Version 1.0.2 of the BIOS includes support for a patch that can disable the automatic baud rate detection for a connected terminal and to work with the predefined speed of 19200 bauds.

For this, you must also slightly modify the Junior Computer ][ motherboard.

Figure 1. Simple patch solution

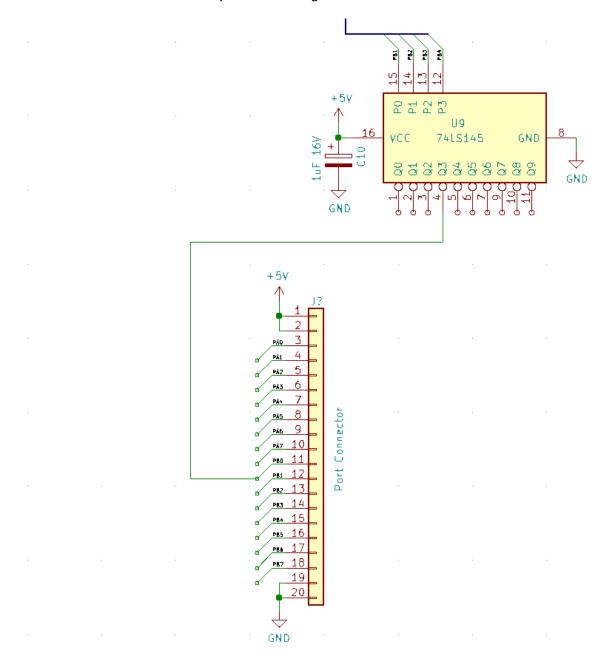
The simplest hardware patch is to connect pin 4 (Q3) of IC U9 (74LS145) to pin 11 (PB0) of the port connector to the left of the hex keyboard via a single wire.

This works fine until you want to run the Junior Computer ][ without a terminal in its native Junior Computer mode using the Hex keyboard and Hex display.

Because the patch, the Junior Computer always switches into the terminal mode and the display won't light up. To fix this issue, you can include a switch in the patch wire, to disconnect the two pins if desired.

Figure 2. Universal patch solution

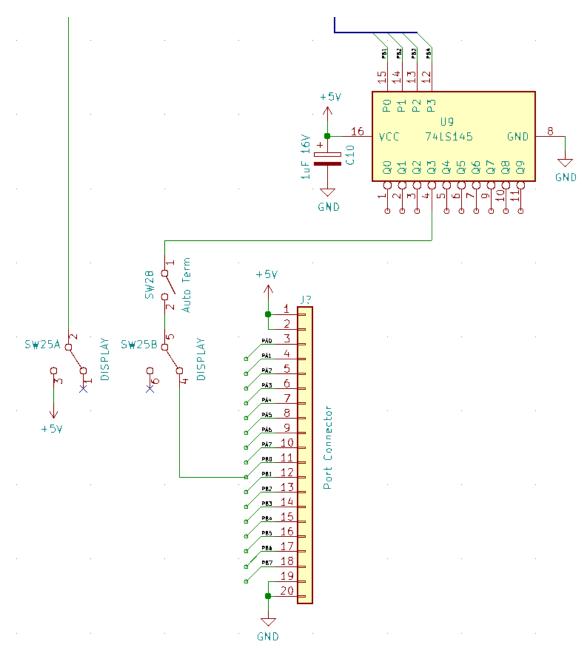
Another solution is to exchange switch 25 (DISPLAY) into a double (toggle) switch like SW24 (STEP). If you then switch the display On (native mode), you deactivate the patch. If you insert a second switch (SW28) like in figure 2, you can additionally disable the patch completely, regardless of whether you need the Hex display or not.
